ADDENDUM NO. 1

**ARCADIA HIGH SCHOOL
LOCKER ROOM ALTERATION
ARCADIA UNIFIED SCHOOL DISTRICT**

tBP/ARCHITECTURE
4611 Teller Avenue
Newport Beach, CA 92660
949-673-0300

This Addendum forms a part of the Contract Documents and modifies the original Bidding Drawings dated August 15, 2024, and Specifications dated July 2024. Acknowledge receipt of this Addendum in space provided on the Bid Form. Failure to acknowledge may subject Bidder to disqualification.

E6.1

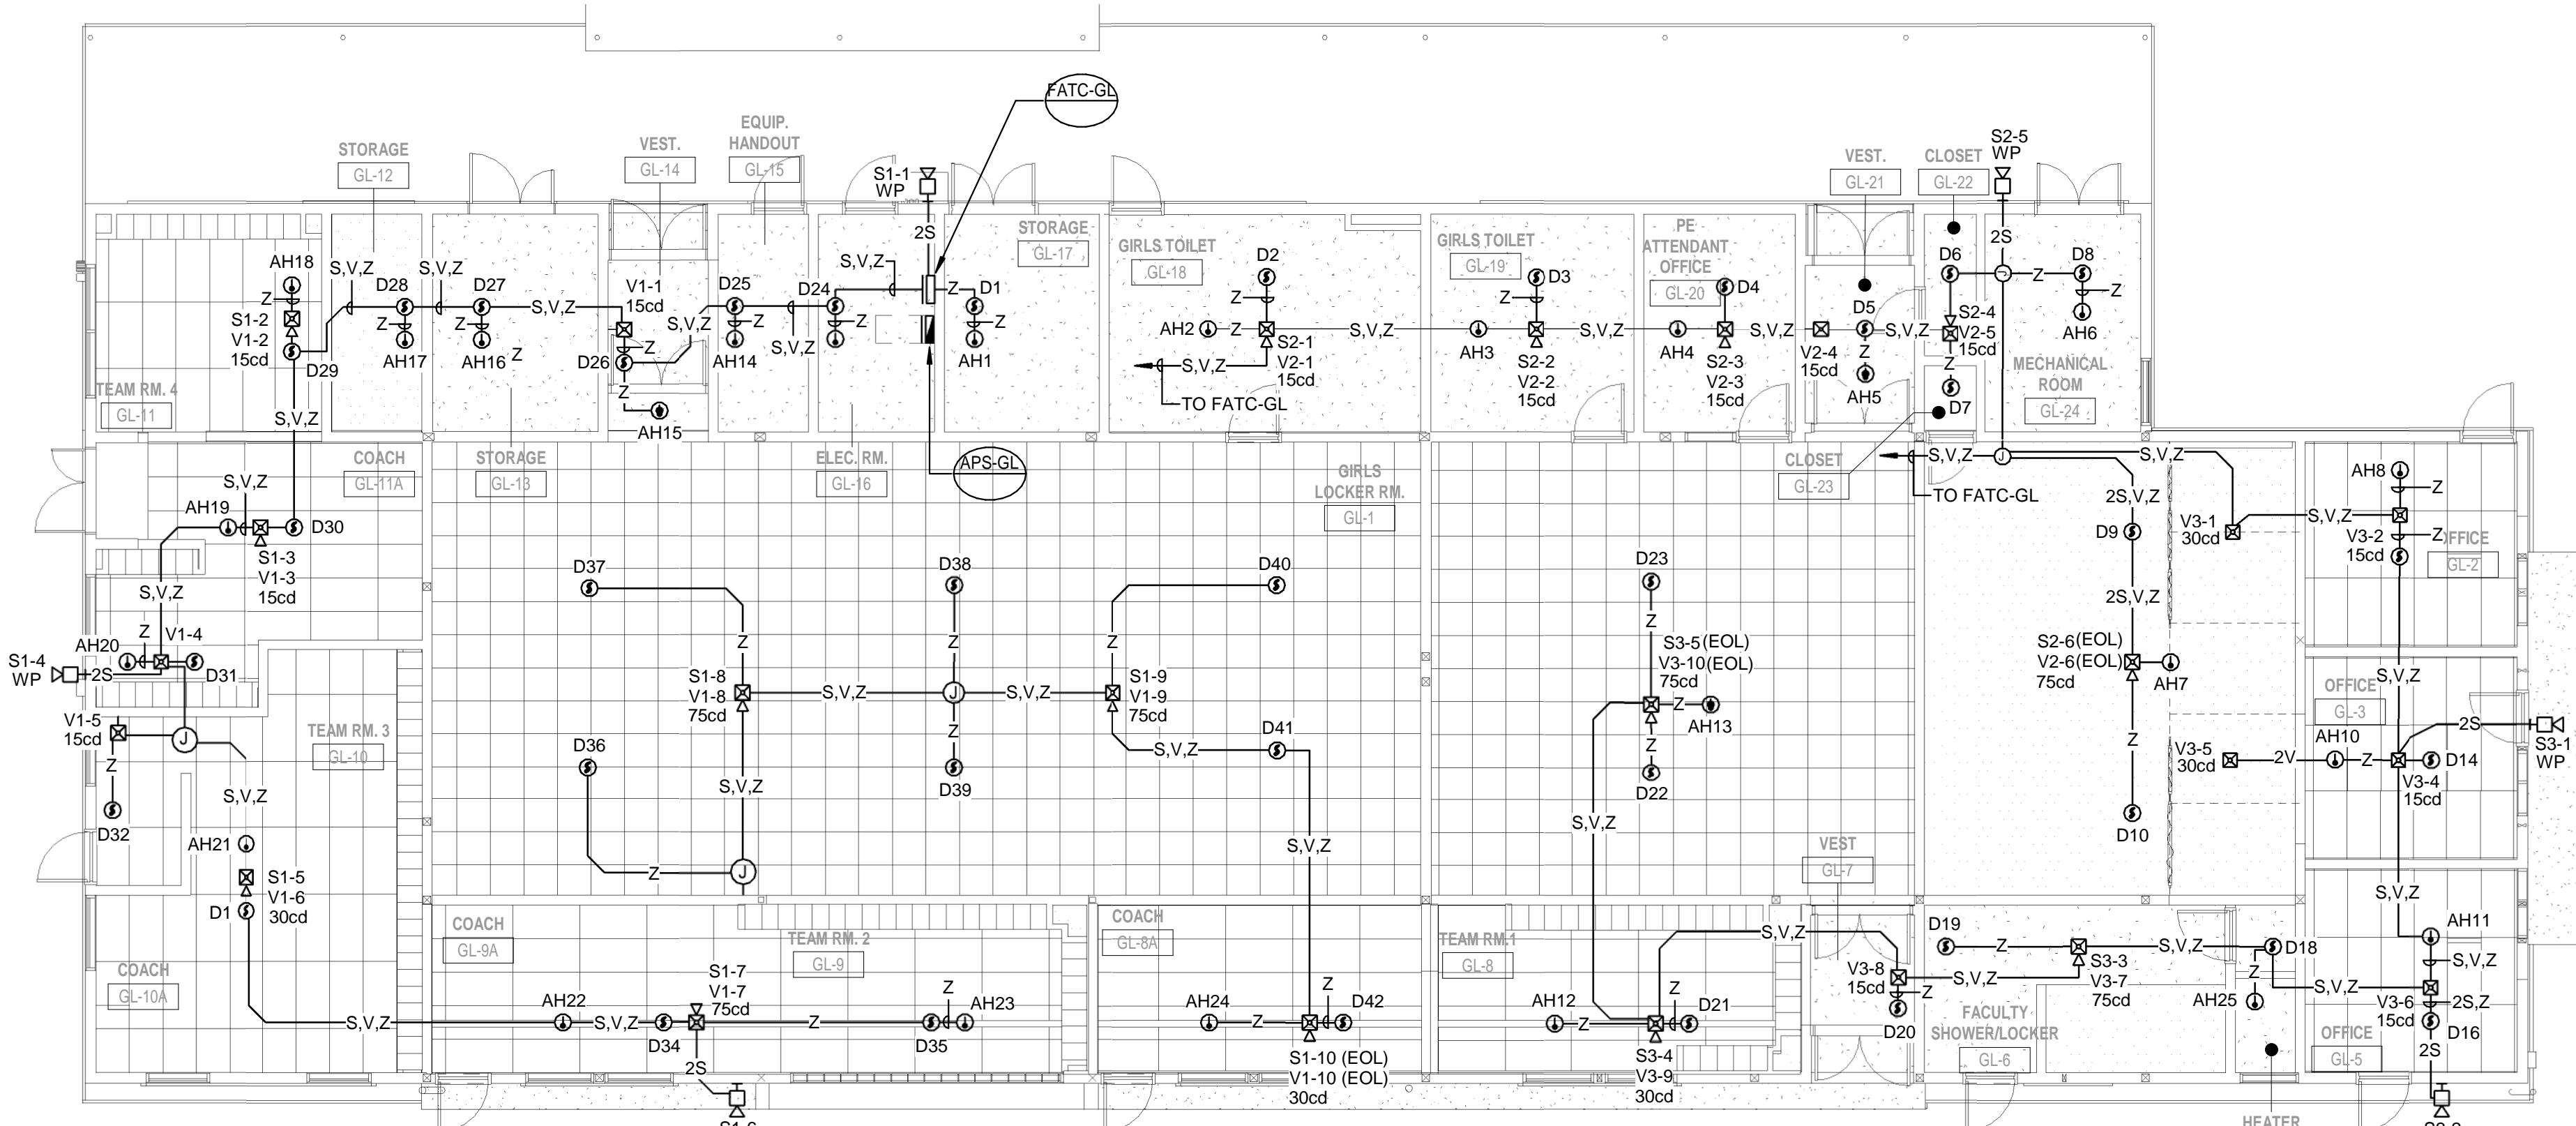
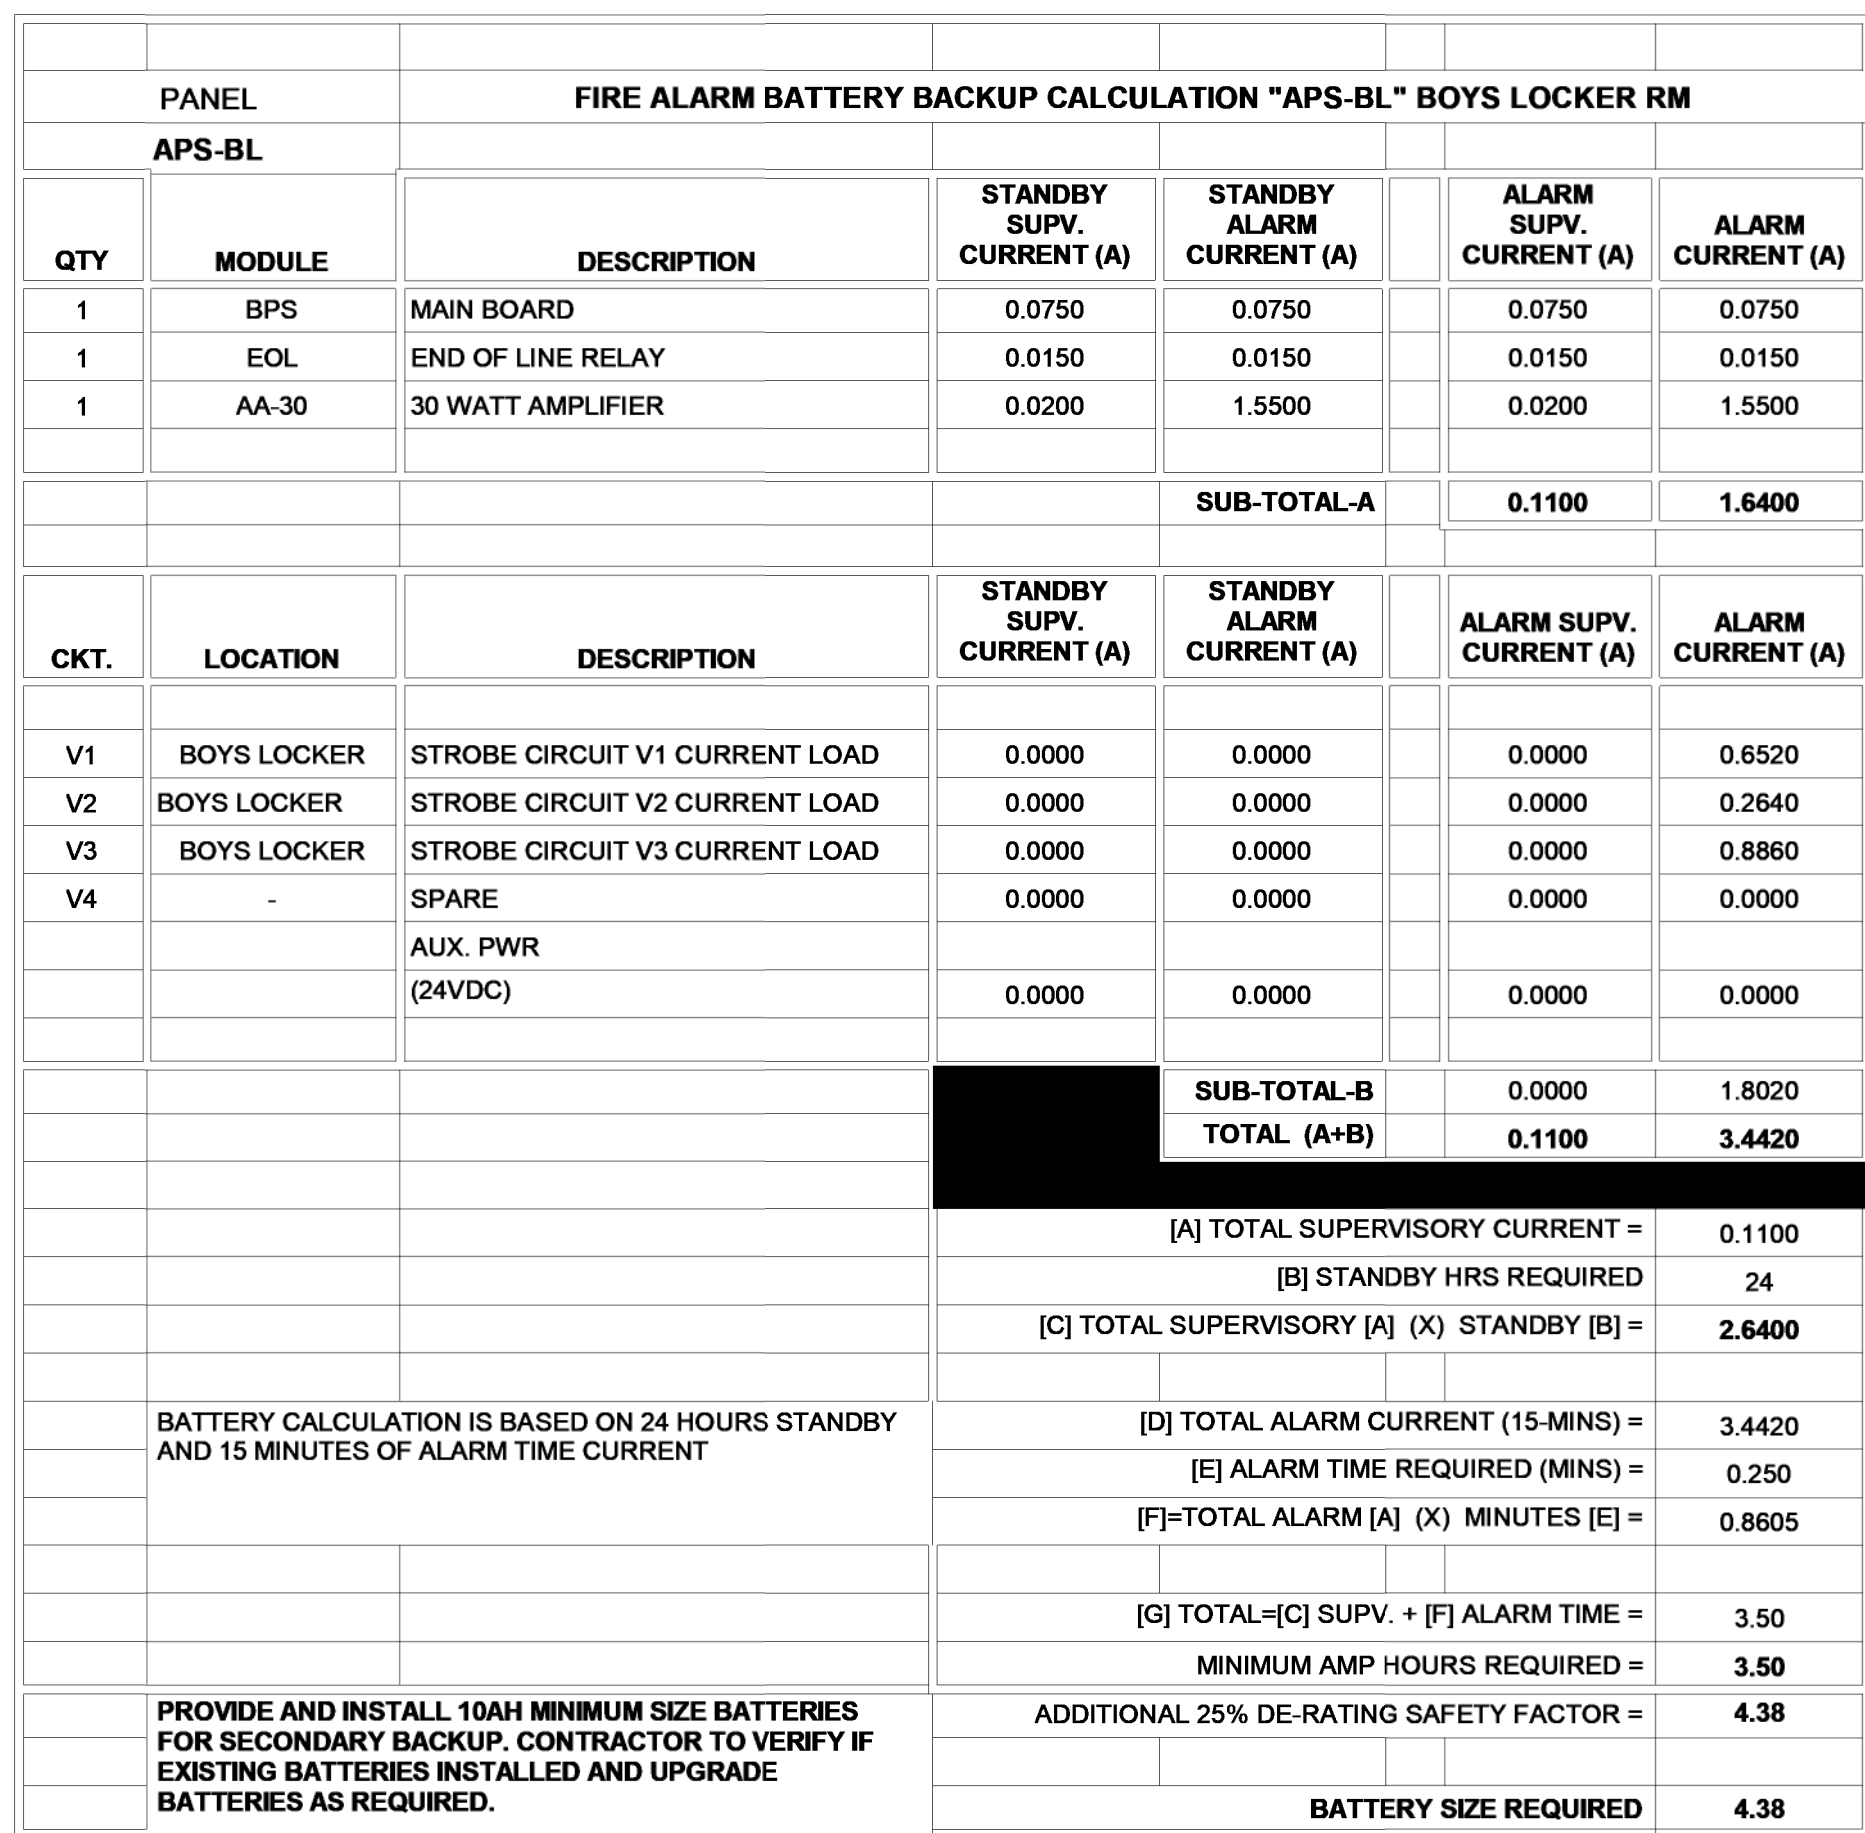
- a. Revise electrical connection to EF/BL5 and EF/BL9 in Building BL.
 - b. Revise electrical connection to EF/GL6 and EF/GL10 in Building GL.
33. SHEET E6.1 – BUILDING BL & GL FIRE ALARM PLAN
Replace full size sheet drawing **E6.1** in its entirety, issued with this addendum.
Changes include:
